United States Patent and Trademark Office

APPLICATION NO	F	FILING DATE	FIRST NAMED INVENTOR	ATTORNEY DOCKET NO.	CONFIRMATION NO.	
10/664,108	09/17/2003		Timothy W. Sheriff	17904-294811	4745	
25764	7590	08/29/2005		· EXAMINER		
FAEGRE PATENT I	-	· - ·	•.	WOLFE, DEBRA M		
		O CENTER		ART UNIT	PAPER NUMBER	
MINNEAP	MINNEAPOLIS, MN 55402			3725		
				DATE MAILED: 08/29/2009	DATE MAILED: 08/29/2005

Application No.	Applicant(s)				
Office Action Commons	10/664,108	SHERIFF, TIMOTHY W.				
Office Action Summary	Examiner	Art Unit				
	Debra Wolfe	3725				
The MAILING DATE of this communication app Period for Reply	ears on the cover sheet with the c	orrespondence address				
A SHORTENED STATUTORY PERIOD FOR REPLY THE MAILING DATE OF THIS COMMUNICATION. - Extensions of time may be available under the provisions of 37 CFR 1.13 after SIX (6) MONTHS from the mailing date of this communication. - If the period for reply specified above is less than thirty (30) days, a reply - If NO period for reply is specified above, the maximum statutory period we - Failure to reply within the set or extended period for reply will, by statute, Any reply received by the Office later than three months after the

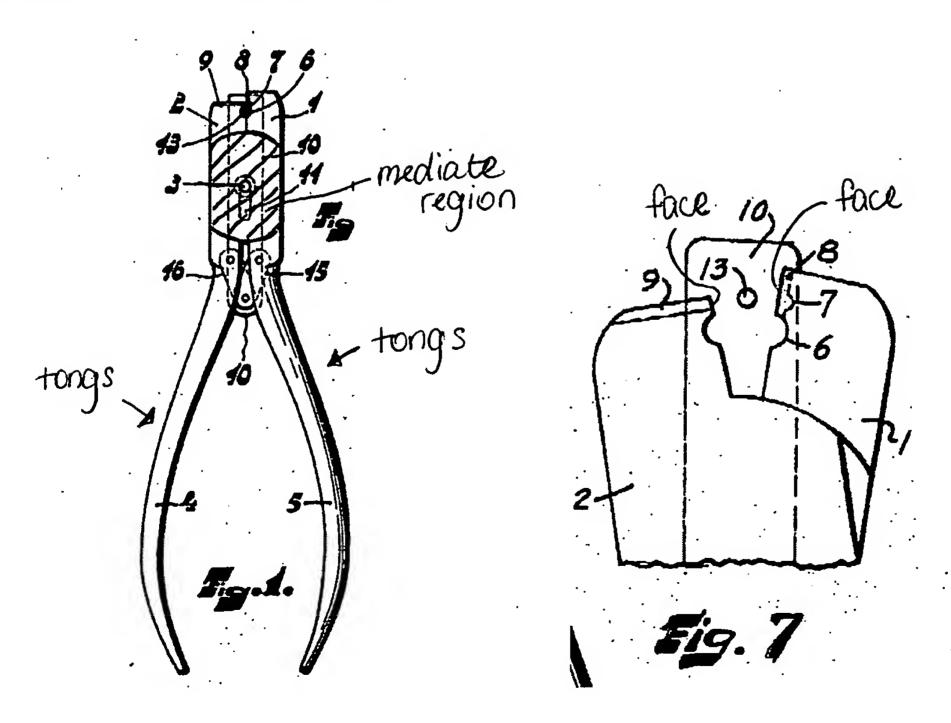
Claims 1-7 are rejected under 35 U.S.C. 102(b) as being anticipated by Knoester (U.S. Patent # 2,824,583). Knoester discloses a loop or eye forming pliers having a first and second member (tongs, See col. 2, line 16), each having a jaw (1, 2) with a flat face (See FIG 7) at a

distal end and a relief (cavities 6) located between the face (See FIG 7) and mediate region (See FIG 1) thereby forming a recess when the first and second members (tongs) are assembled with the faces opposing each other, a handle (handles 4, 5) and a mediate region (See FIG 1); a connecting means (common pivot 3) for securing the first and second members together at the mediate region and for preventing pivoting movement between the first and second members while locating the jaws on the same side of the connecting means such that the jaws are opposed to each other and free to move towards and away from each other (See FIG 1); a link (plate 10) attached to the mediate region (See FIG 1) of the first and second members (tongs) having a post (core pin 13) projecting from the link (plate 10) and projecting into the recess formed by the reliefs (cavities 6) of the jaws (1, 2).

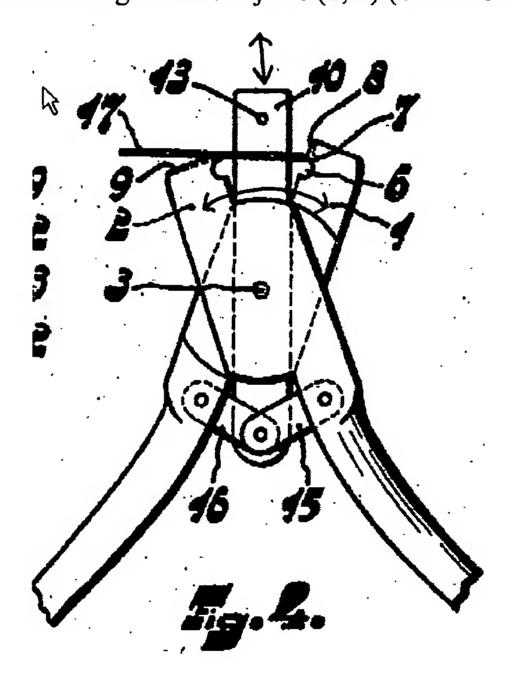
As it appears in Knoester the link (plate 10) is loosely secured to the mediate region (See FIG 1) of the first and second members (tongs) to permit limited movement of the post within the recess and the post (core pin 13) is free to move towards and away from the connecting means (common pivot 3) through a slot (11) on the link (plate 10). Figure 4 of Knoester appears to show the jaws (1, 2) having a closing arc and the post (core pin 13) having a limited movement generally perpendicular to the closing arc of the jaws (1, 2) (See arrows of FIG 4).
